Re: Port Authority of Allegheny County
East Busway Rock Slope Stabilization Study
Geotechnical Engineering Report

ATTACHMENT 1
FIELD RECONNAISSANCE PLANS AND PHOTOGRAPHS

PORT AUTHORITY OF ALLEGHENY COUNTY
 PITTSBURGH PENNSYLVANIA
 EAST BUSWAY
 PLAN
 STA. 220+22.69 TO STA. 222+50
 MICHAEL BAKER, JR., INC.
 CONSULTING ENGINEERS
 BEAVER, PENNSYLVANIA

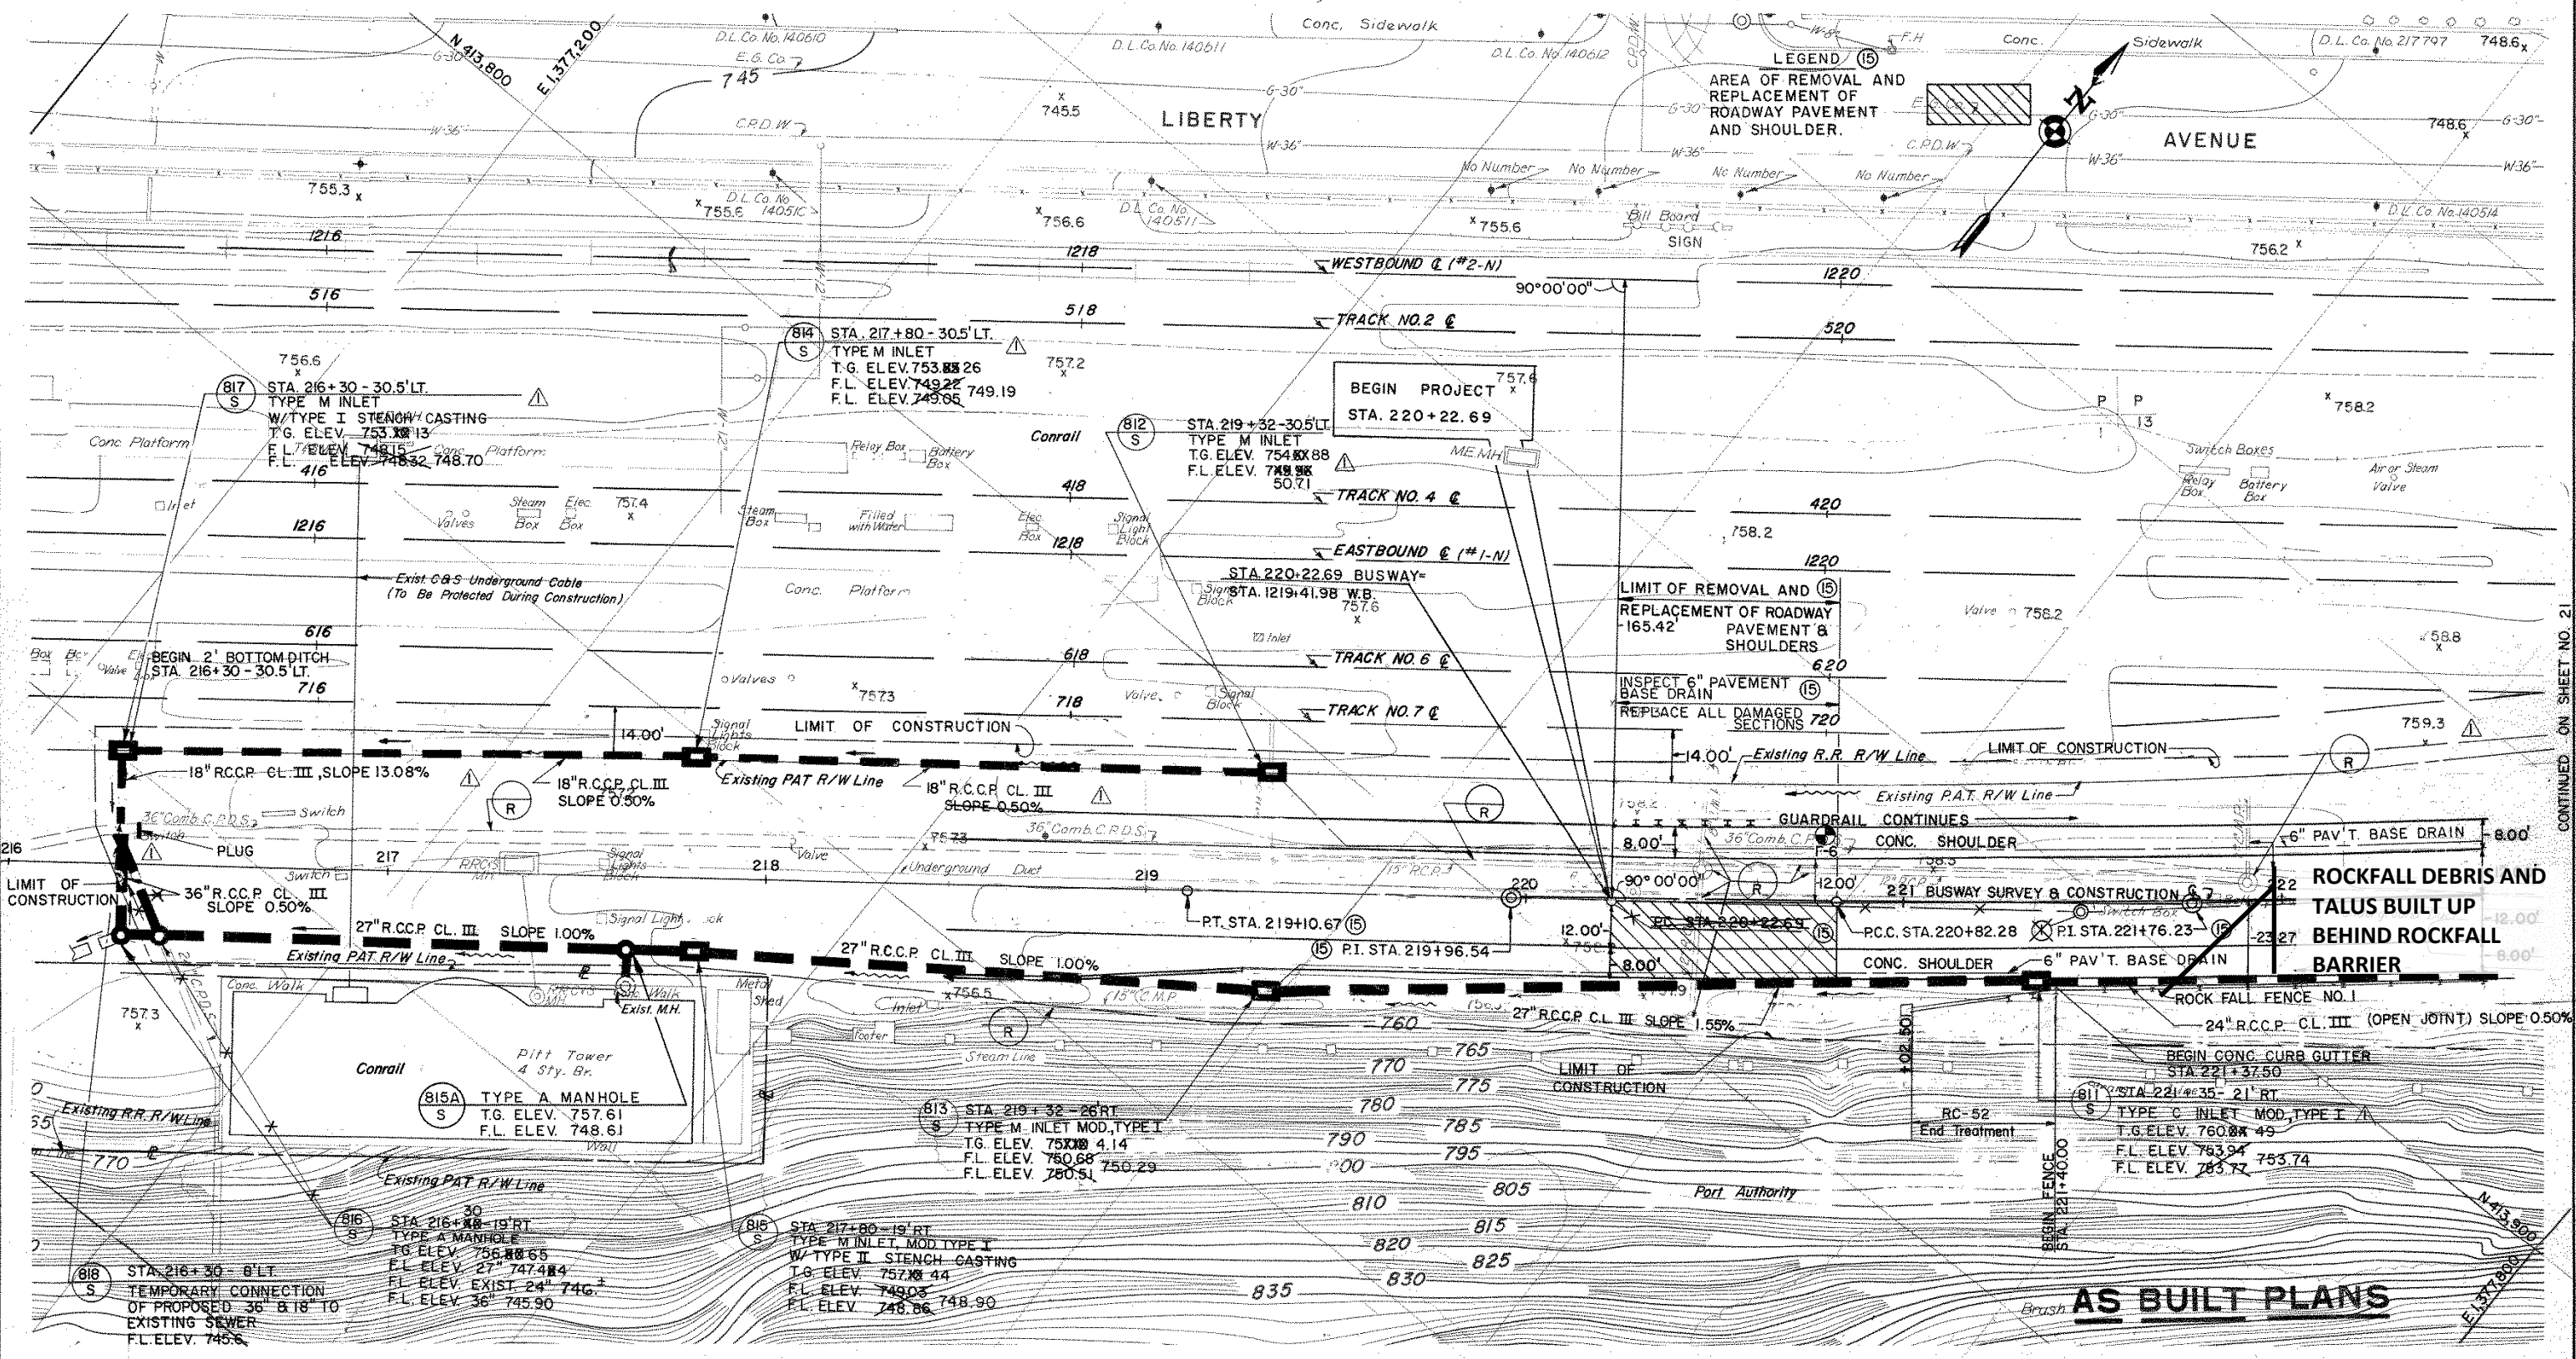
ROCKFALL BARRIER POSTS AND FACING DAMAGED BEYOND REPAIR BETWEEN STATIONS 222+62 TO 223+12. RECOMMEND REPLACEMENT OF THIS SECTION.

PORT AUTHORITY OF ALLEGHENY COUNTY
 PITTSBURGH, PENNSYLVANIA
 EAST BUSWAY
 PLAN
 STA. 222+50 TO STA. 228+50
 MICHAEL BAKER, JR., INC.
 CONSULTING ENGINEERS
 BEAVER, PENNSYLVANIA

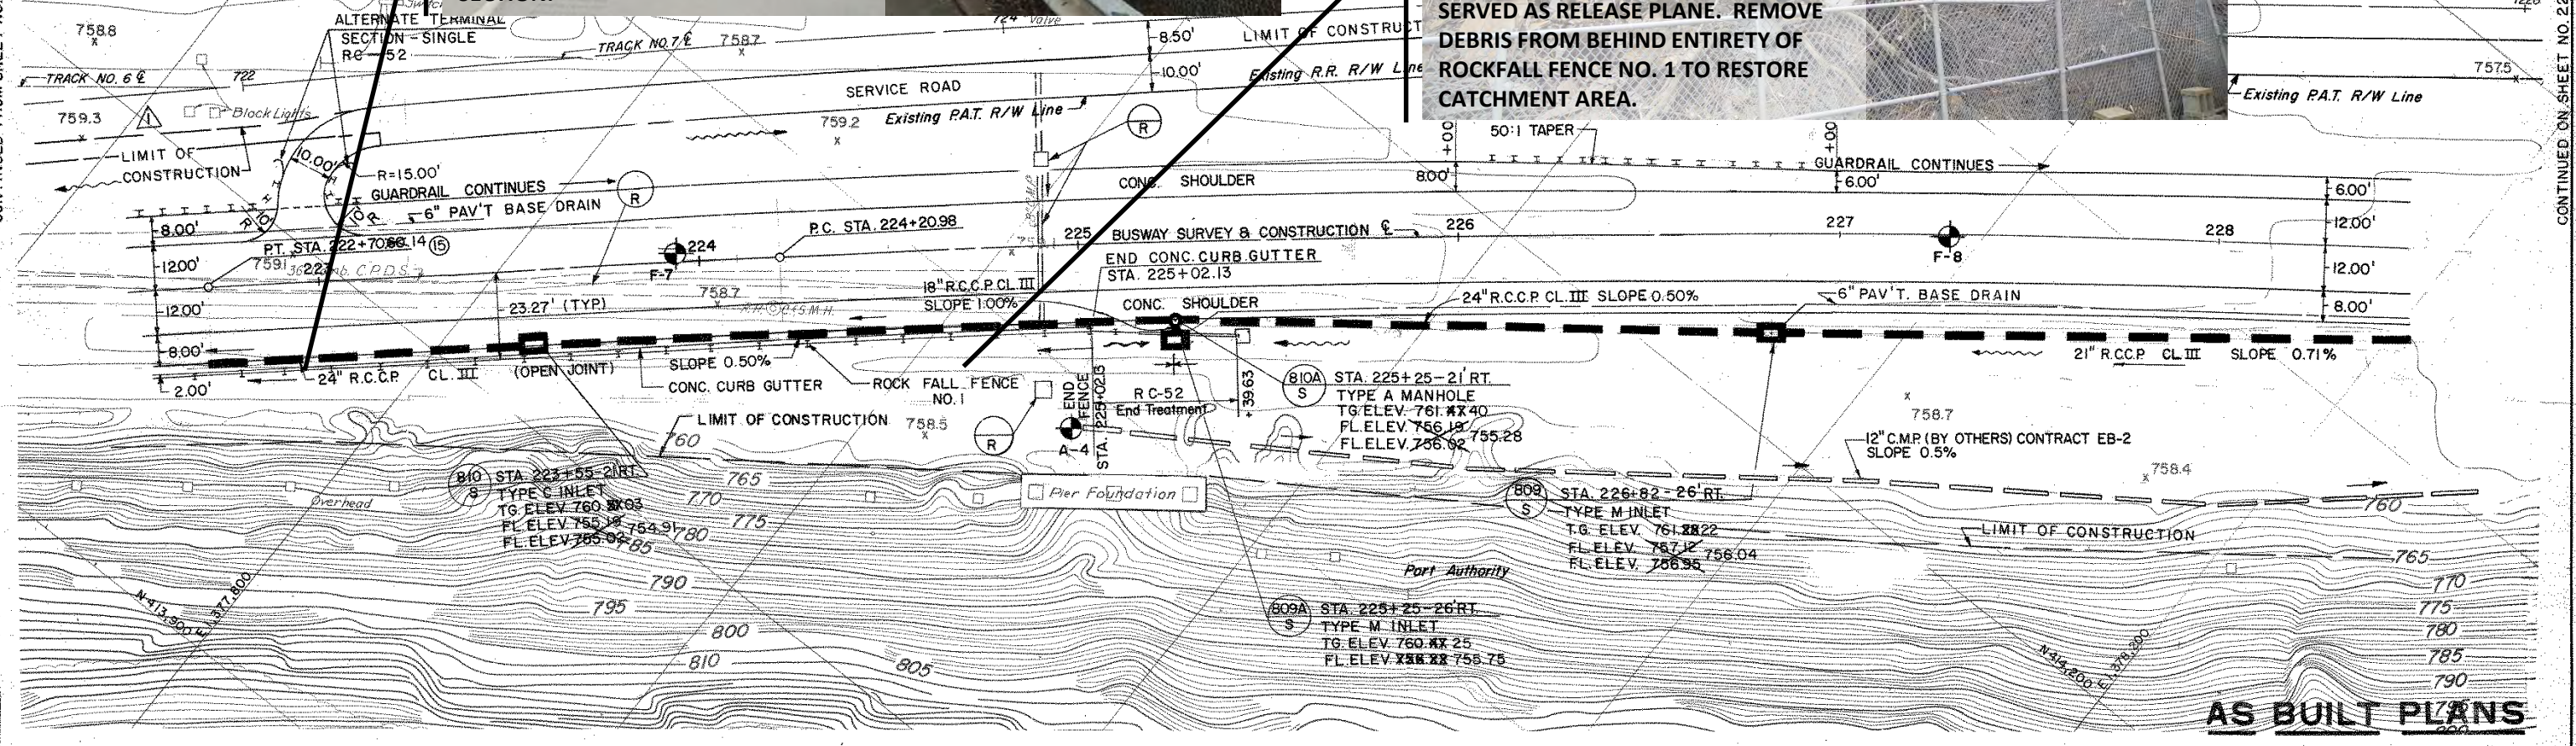
ROCKFALL AND TALUS BUILD UP BEHIND DOG TRAINING AREA. NOTE VALLEY STRESS RELIEF JOINT IN SLOPE SERVED AS RELEASE PLANE. REMOVE DEBRIS FROM BEHIND ENTIRETY OF ROCKFALL FENCE NO. 1 TO RESTORE CATCHMENT AREA.

PORT AUTHORITY OF ALLEGHENY COUNTY
 PITTSBURGH, PENNSYLVANIA
 EAST BUSWAY
 PLAN
 STA. 228+50 TO STA. 234+50
 MICHAEL BAKER, JR., INC.
 CONSULTING ENGINEERS
 BEAVER, PENNSYLVANIA

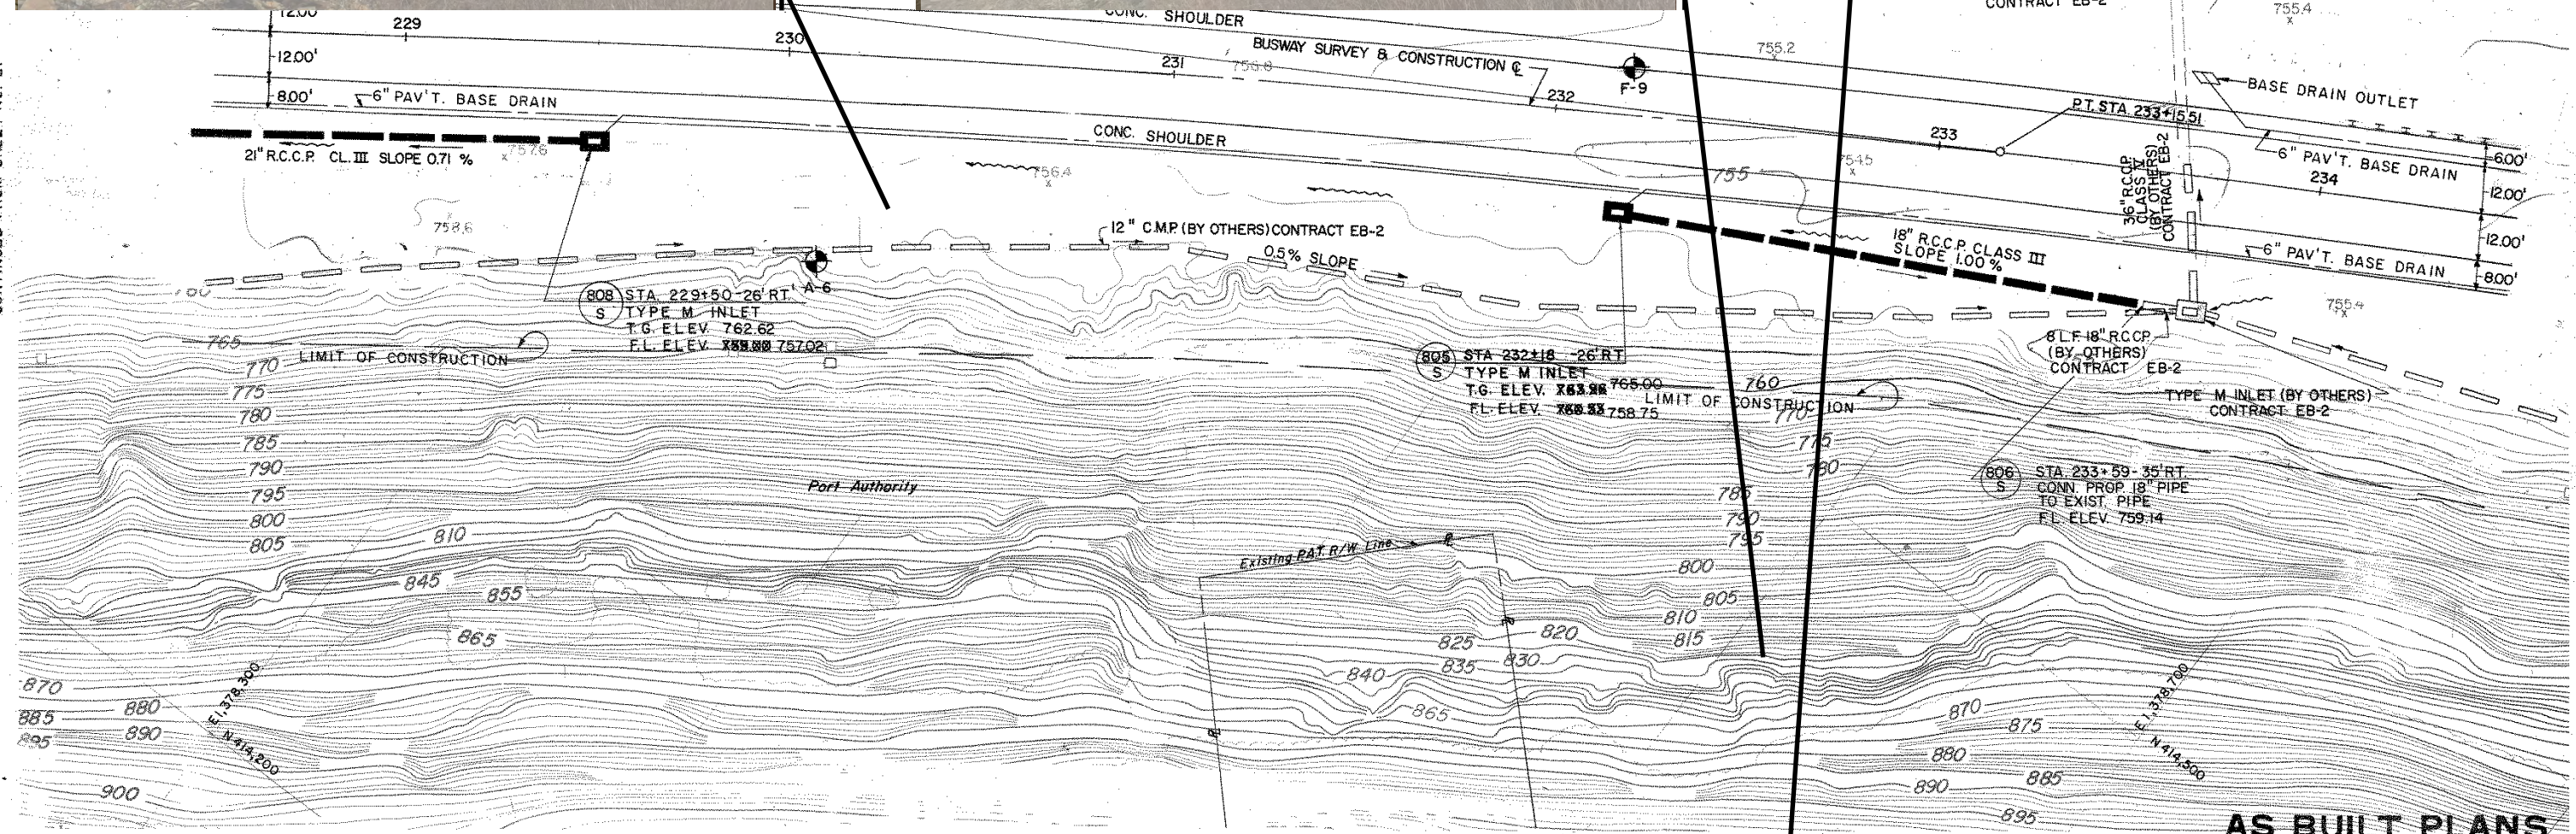
ROCKFALL FROM TOP OF SLOPE. DEBRIS PATH EXTENDS TO EDGE OF BUSWAY. LARGE OVERHANGS POSE ADDITIONAL ROCKFALL THREAT TO BUSWAY. RECOMMEND REMOVAL OF ROCKFALL DEBRIS FROM CATCHMENT AREA BETWEEN STA. 230+00 AND 237+00.

UNDERCUT ROCKBLOCK NEAR TOP OF SLOPE ILLUSTRATES VALLEY STRESS AND TECTONIC JOINT SETS.

STONE WALL AT THE TOP OF THE SLOPE ADJACENT TO BIGELOW BOULEVARD

EAST BUSWAY
 PLAN
 STA. 234+50 TO STA. 240+50

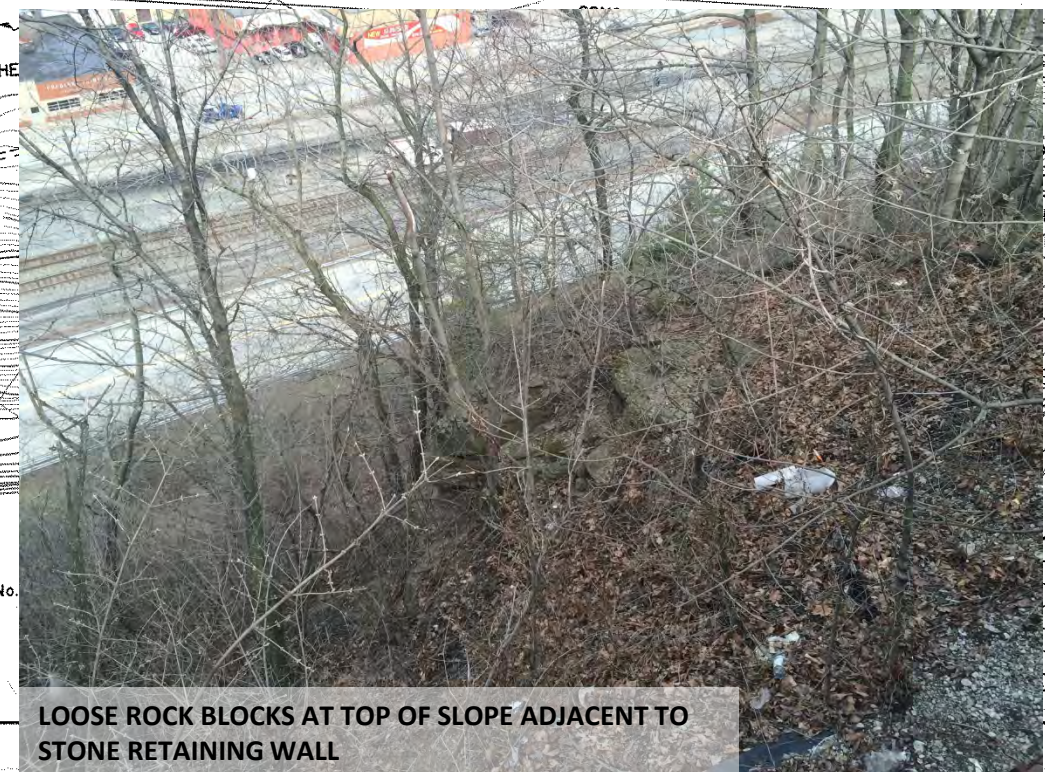
VALLEY STRESS RELIEF JOINT TRENDING INTO SLOPE. NOTE UNDERCUTTING AT BASE OF ROCK BLOCK.

TALUS BUILD UP BEHIND ROCKFALL BARRIER. CATCHMENT AREA IS COMPLETELY FILLED AND BARRIER IS SERVING AS RETAINING WALL

LOOSE ROCK BLOCKS AT TOP OF SLOPE ADJACENT TO STONE RETAINING WALL

PORT AUTHORITY OF ALLEGHENY COUNTY
 PITTSBURGH, PENNSYLVANIA
 EAST BUSWAY
 PLAN
 STA. 240+50 TO STA. 246+50
 MICHAEL BAKER, JR., INC.
 CONSULTING ENGINEERS
 BEAVER, PENNSYLVANIA

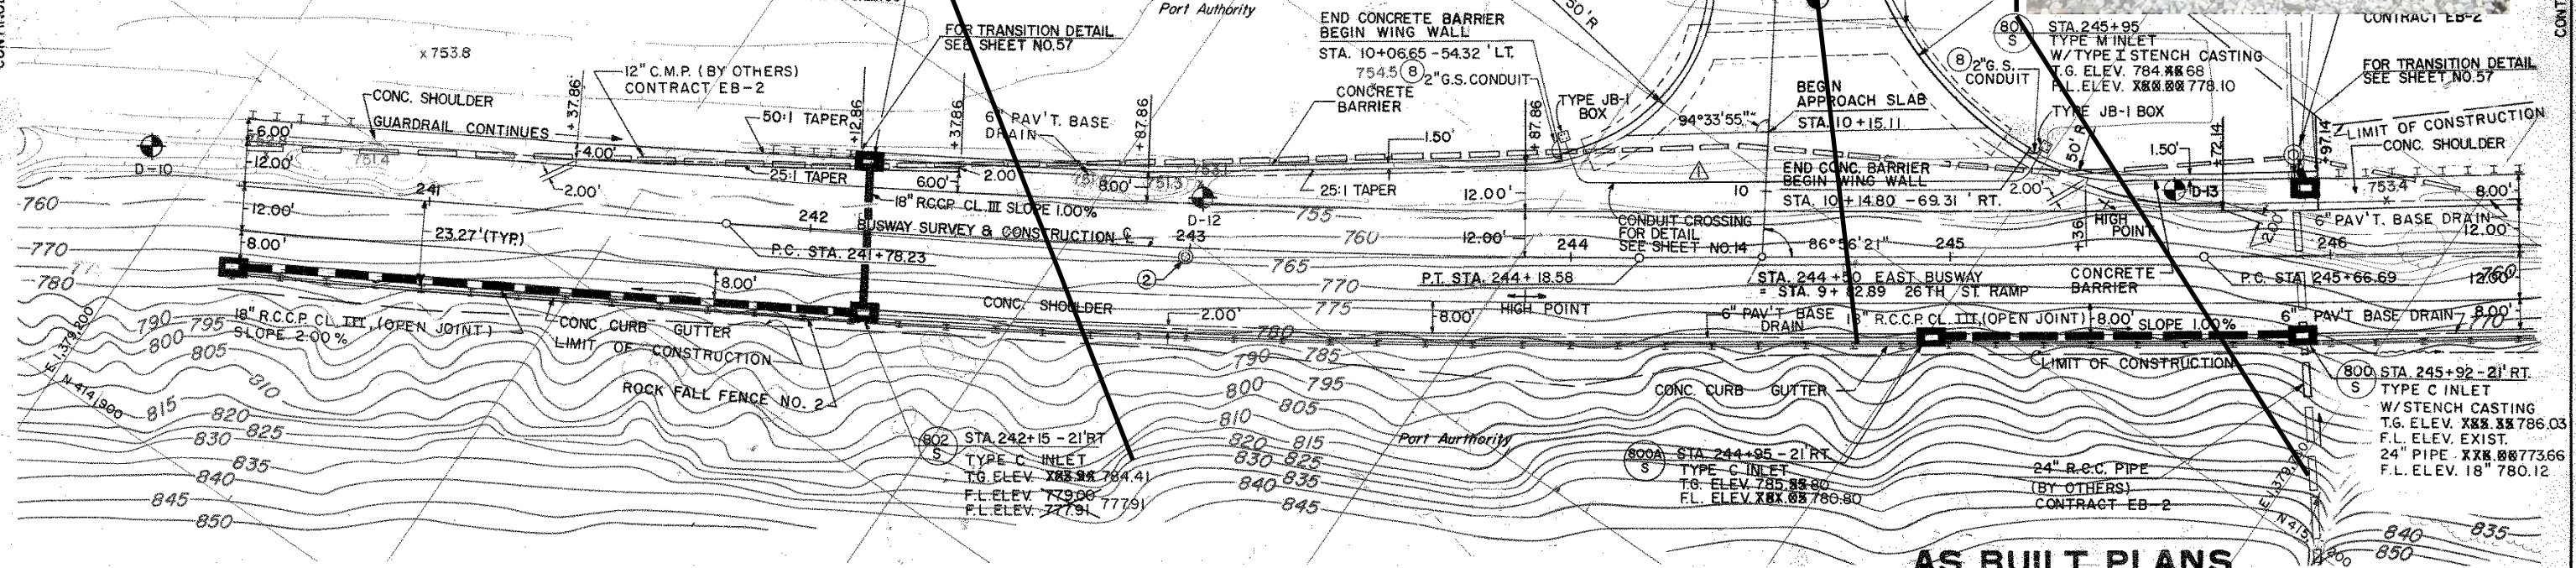
TALUS BUILD UP BEHIND ROCKFALL BARRIER. CLAYSTONE EXPOSED IN SLOPE.

DAMAGED CONDUIT WITHIN ROCKFALL BARRIER AND ELECTRICAL LINE RELOCATION.

REPAIRED SLOPE DRAIN PIPE.
